UNITED STATES PATENT AND TRADEMARK OFFICE

APPLICATION NO.	FILING DATE	FIRST NAMED INVENTOR	ATTORNEY DOCKET NO.	CONFIRMATION NO.
10/707,805	01/13/2004	Yi-Nan Chen	NTCP0027USA	1804
27765	7590	10/06/2004	EXAMINER	
NAIPO (NORTH AMERICA INTERNATIONAL PATENT OFFICE) P.O. BOX 506 MERRIFIELD, VA 22116			GEBREMARIAM, SAMUEL A	
			ART UNIT	PAPER NUMBER
			2811

Office Action Summary

FIG. 10

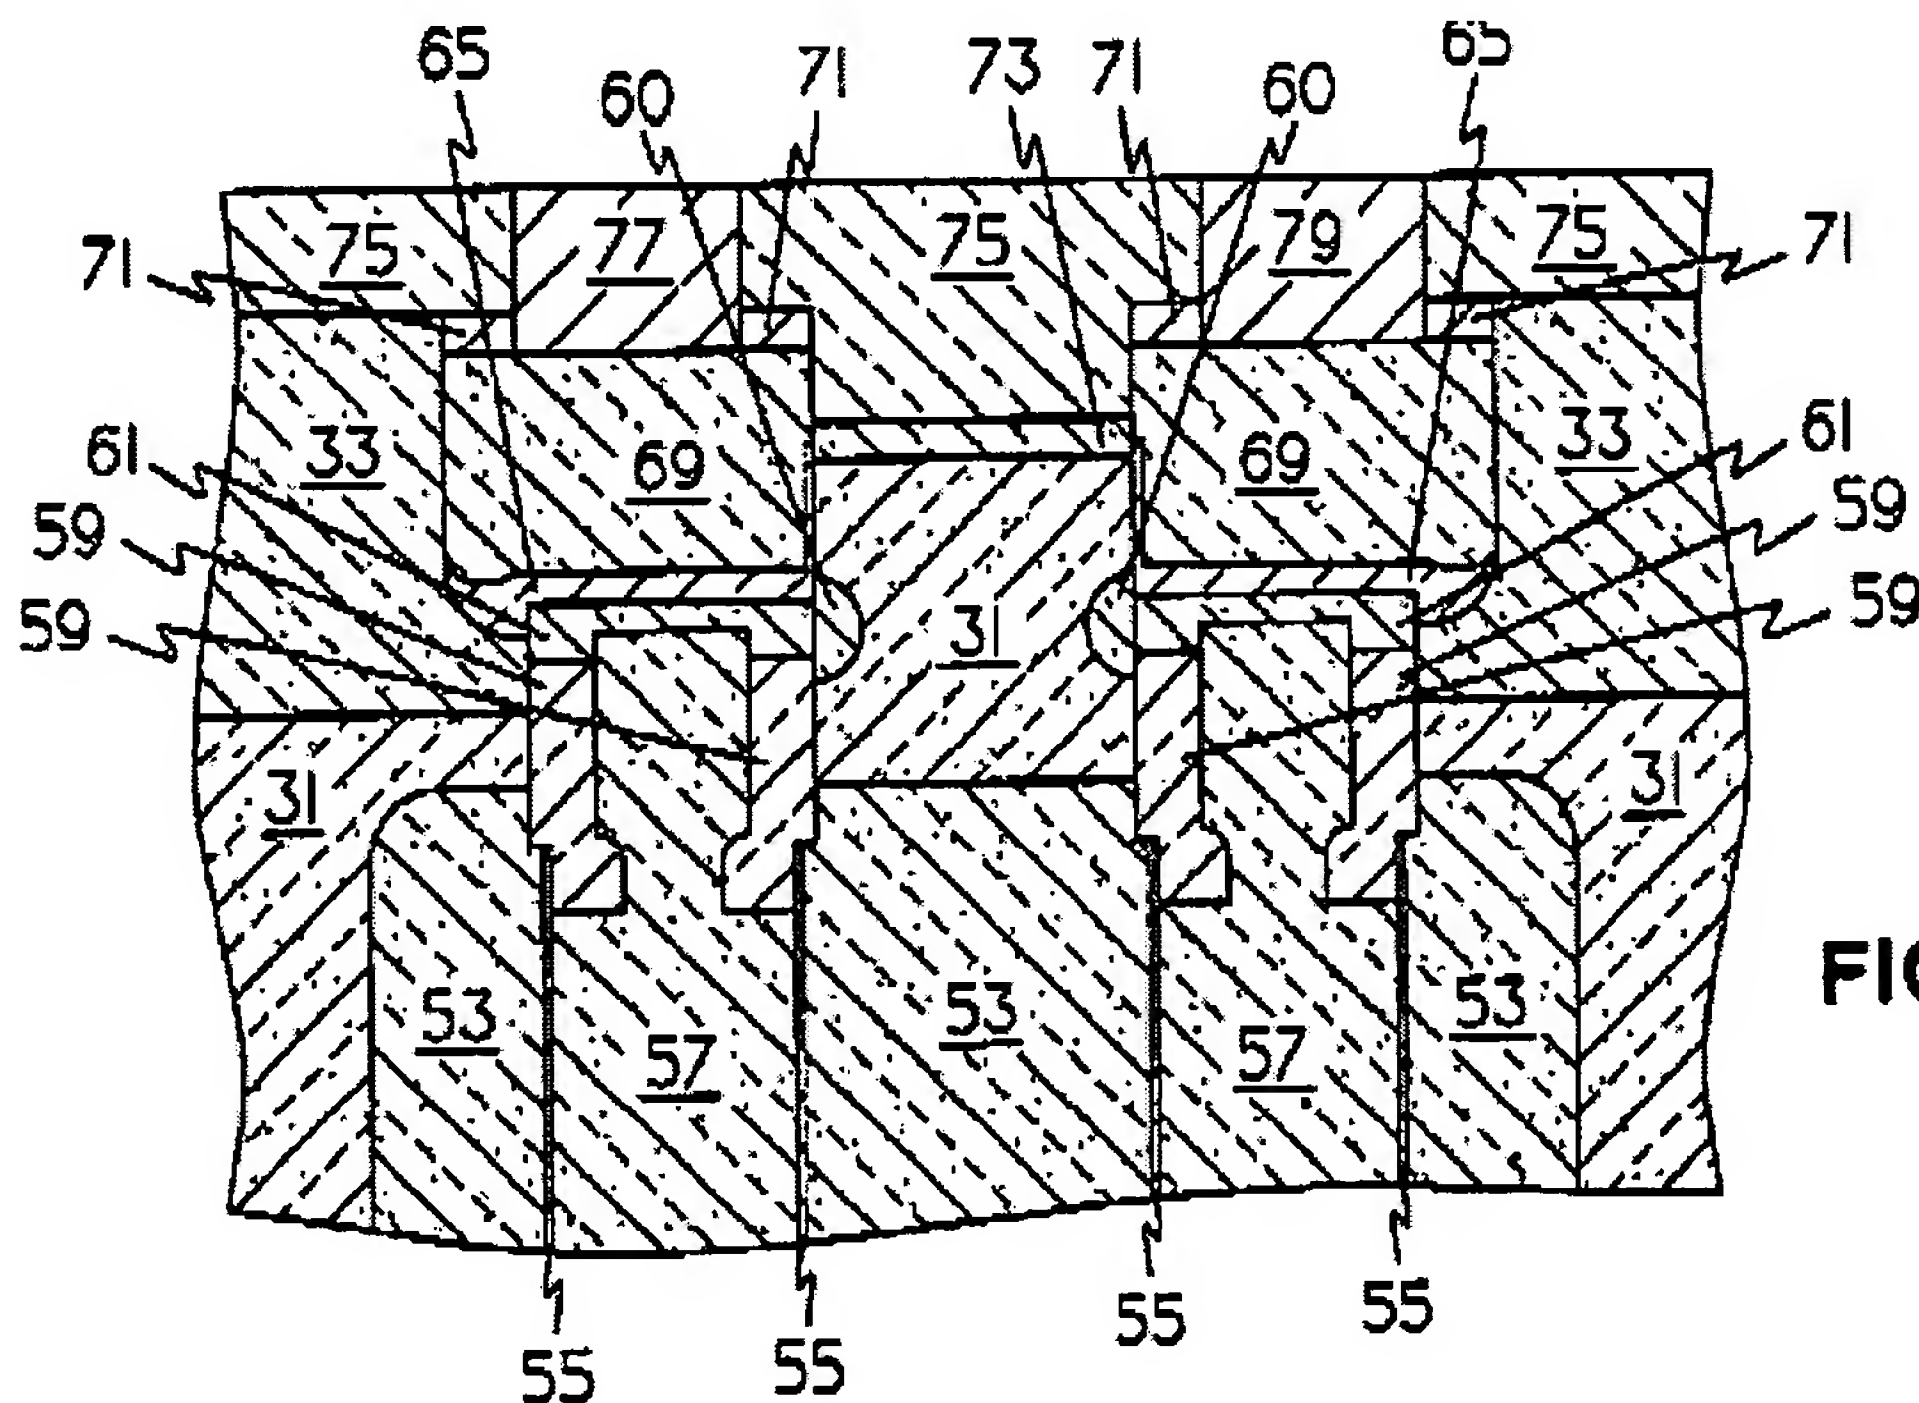
Regarding claim 1, Furukawa teaches (figs. 1-10) an isolation structure of a trench capacitor (75 in the middle, fig. 10), the trench capacitor being disposed in a deep trench (39) of a substrate (31) and comprising a conductive layer (57, 69) in the deep trench and a collar oxide layer (59) disposed on a surface of a sidewall of the

deep trench, the isolation structure comprising: a first isolation portion (portion of 75 on the top left and right) covering the conductive layer and filling a top opening of the deep trench (fig. 10), the first isolation portion having a first thickness; and a second isolation portion (the isolation portion of 75 that is thicker) directly contacting the first isolation portion and surrounding the deep trench without overlapping the deep trench (fig. 10), the second isolation portion having a second thickness larger than the first thickness (the 2nd isolation portion goes deeper than the 1st isolation portion).

Regarding claim 2, Furukawa teaches the entire claimed structure of claim 1 above including the second isolation portion is disposed by a side of the collar oxide layer (59), near the conductive layer (57, 69) and the collar oxide layer (59) without being located on the conductive layer (57, 69).
